# CONSTRUCTION DOCUMENTS MAYBERRY, COLORADO - FILING NO. 4

BEING A REPLAT OF TRACT A, MAYBERRY, COLORADO SPRINGS FILING NO. 3  
LYING THE NORTHEAST QUARTER OF SECTION 14, TOWNSHIP 14 SOUTH, RANGE 63 WEST OF THE 6TH PRINCIPAL MERIDIAN  
COUNTY OF EL PASO (UNINCORPORATED), STATE OF COLORADO

PCD FILE NO. SF2317

NO. **C3.0**

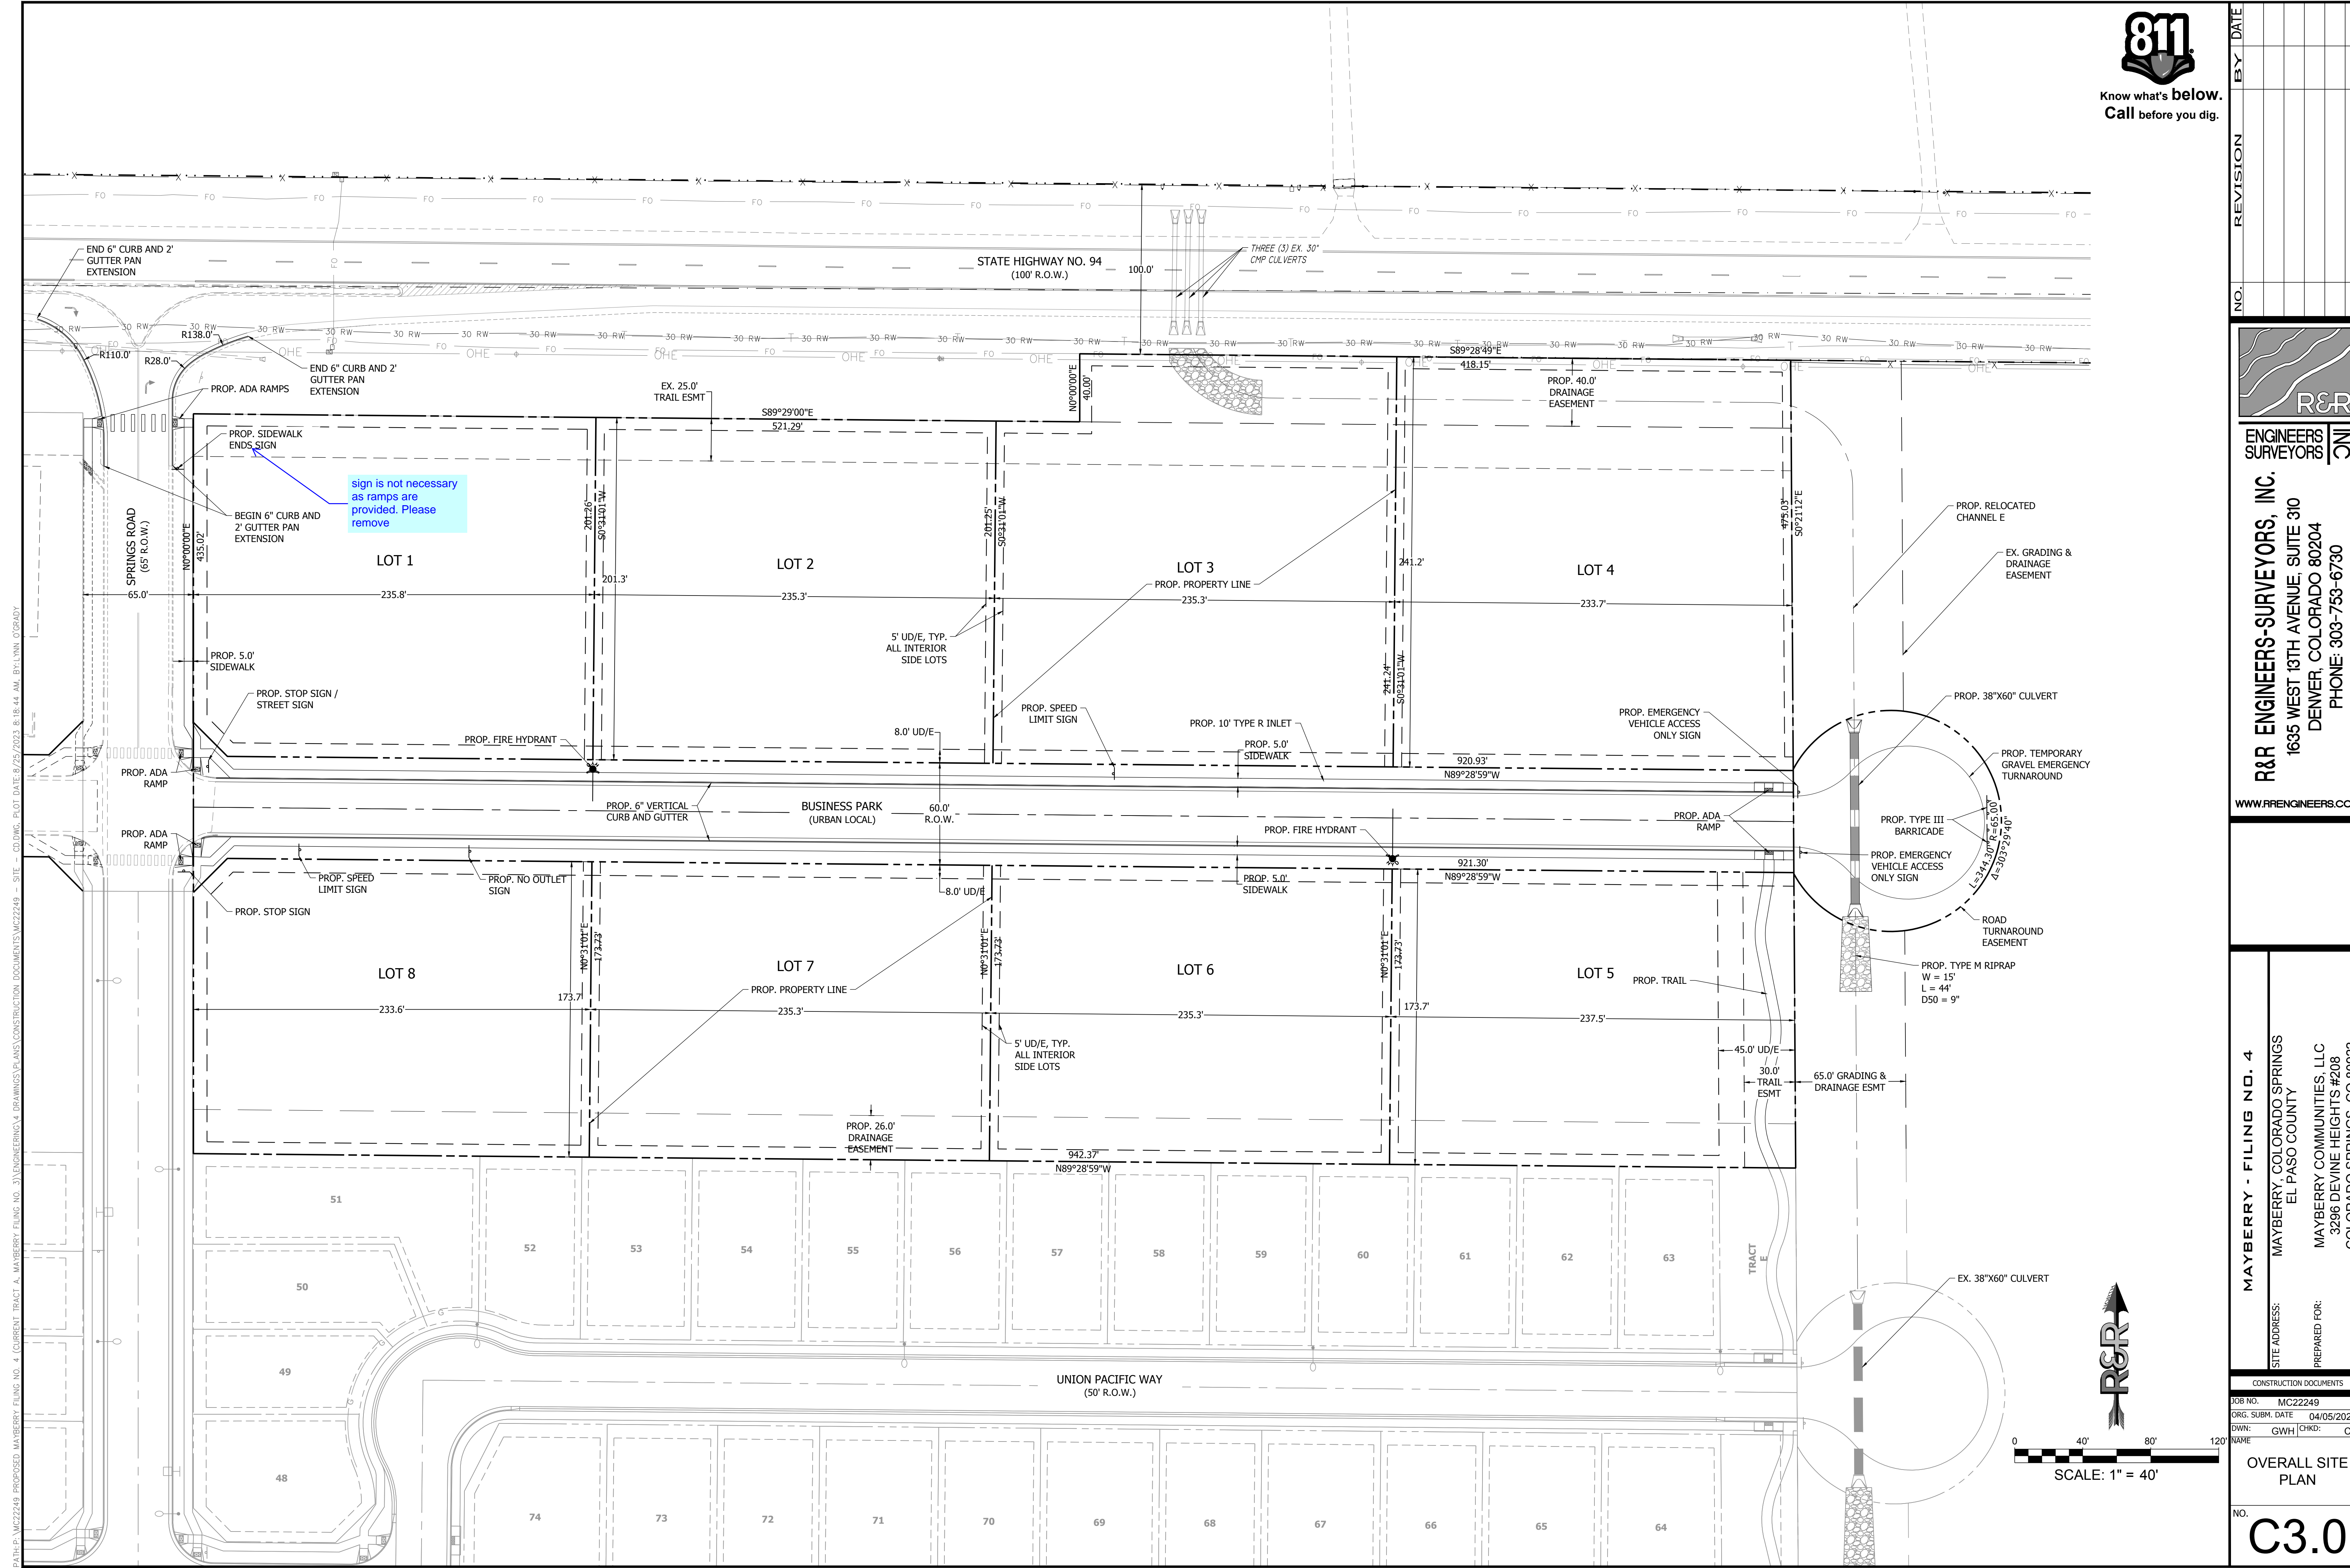
sign is not necessary as ramps are provided.  
Please remove

**BUSINESS PARK PLAN & PROFILE - EAST**

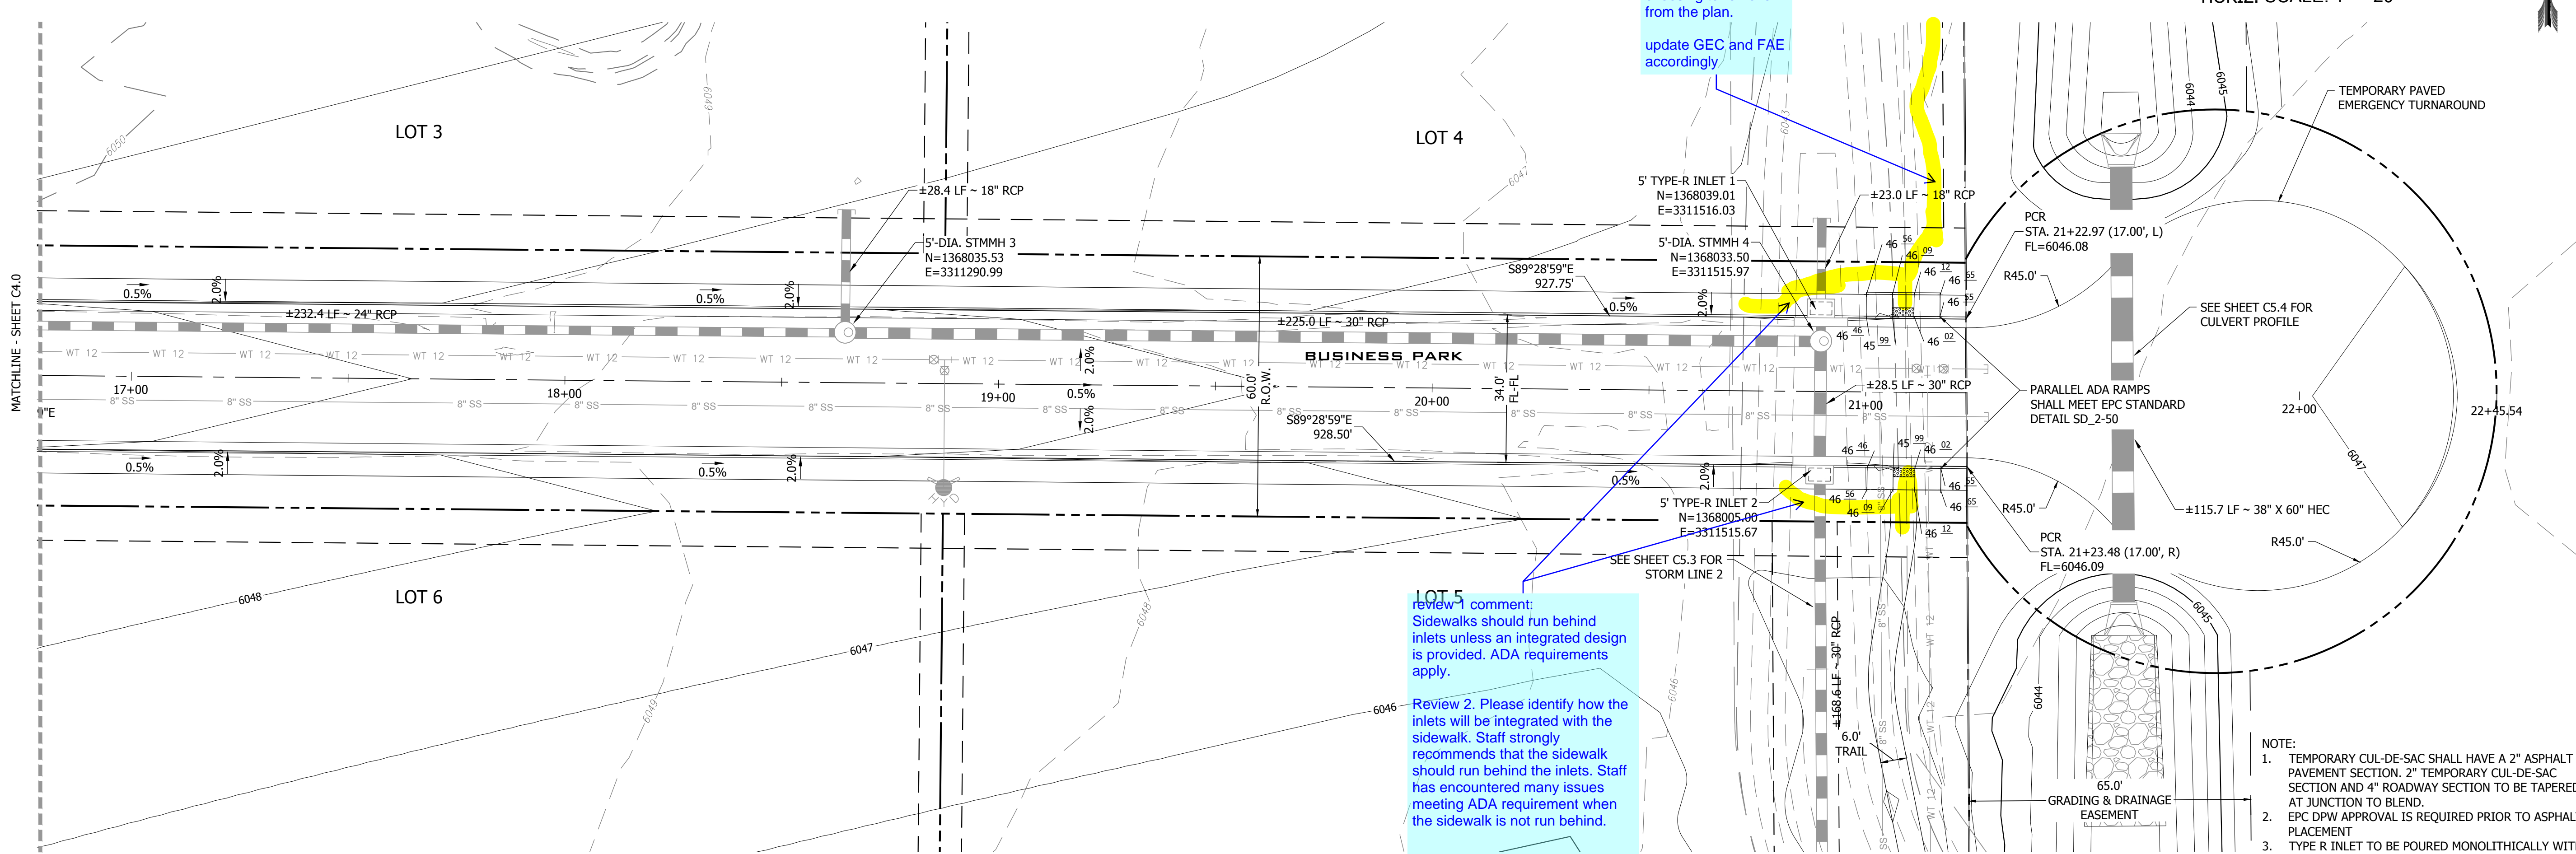
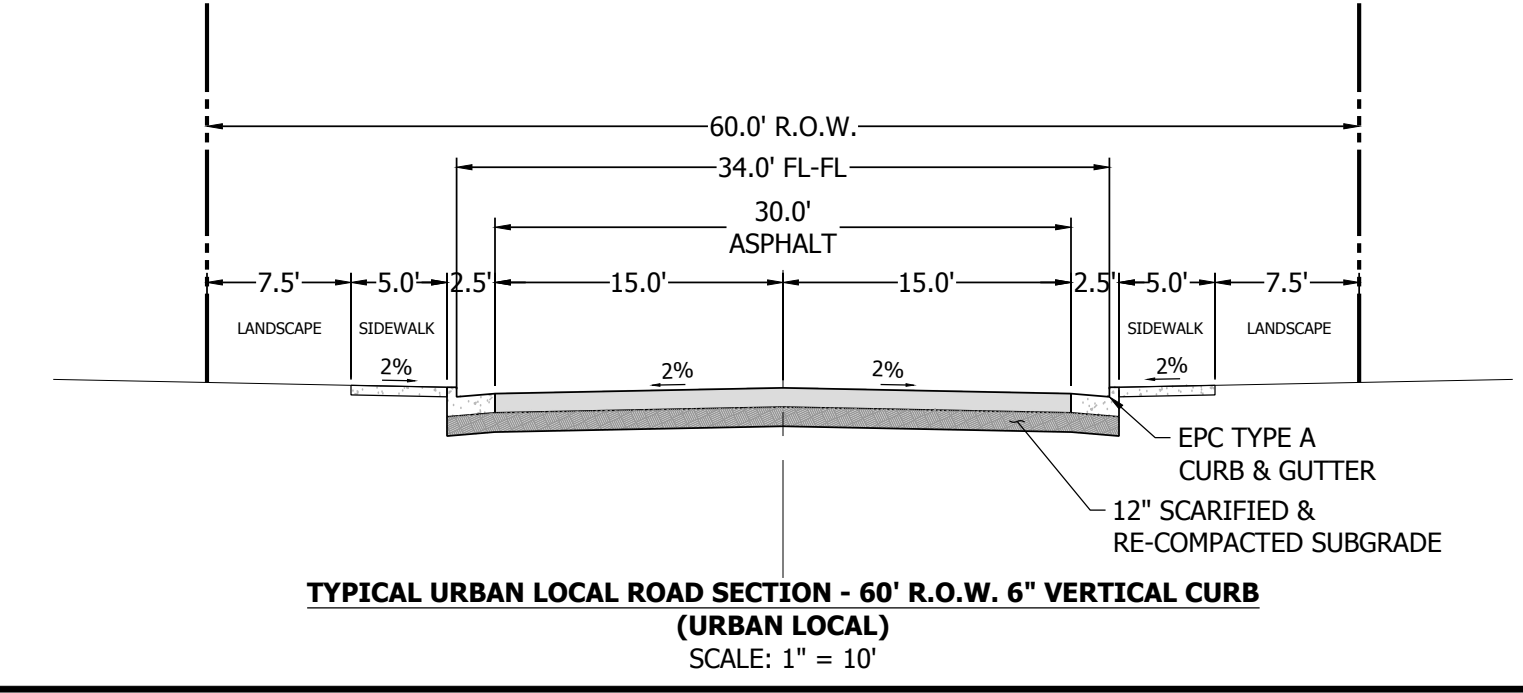
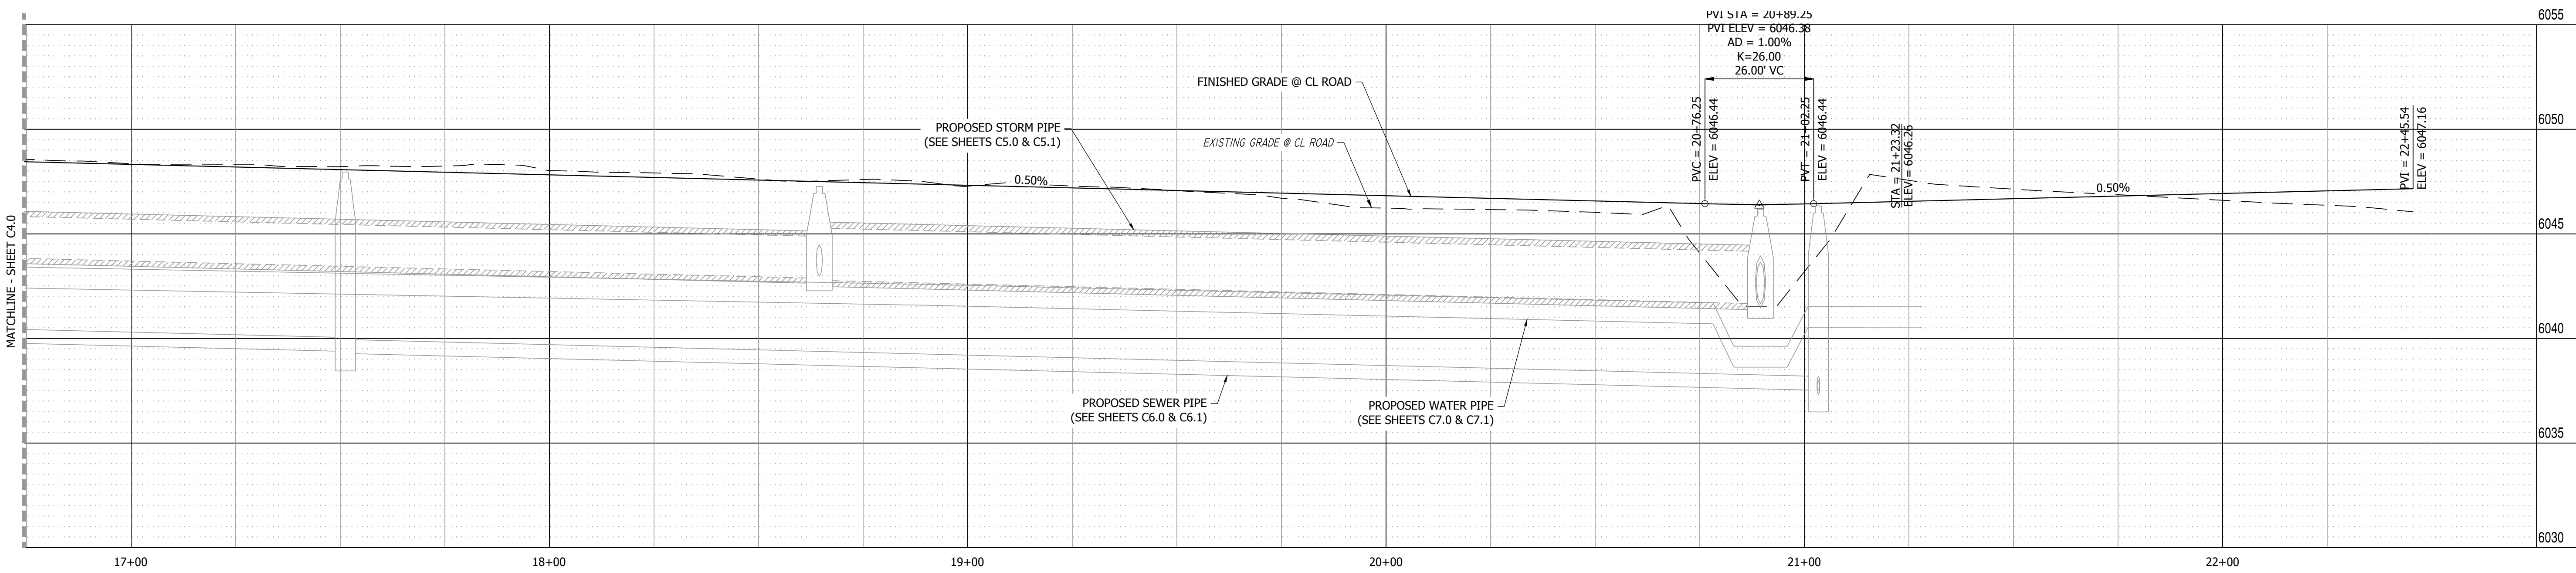
Trail was identified in the PUD plan. Please provide. Contact the planner Ryan H., whether a PUD change is needed if choosing to remove from the plan.  
update GEC and FAE accordingly

review comment: Sidewalks should run behind inlets unless an integrated design is provided. ADA requirements apply.  
Review 2. Please identify how the inlets will be integrated with the sidewalk. Staff strongly recommends that the sidewalk should run behind the inlets. Staff has encountered many issues meeting ADA requirement when the sidewalk is not run behind.
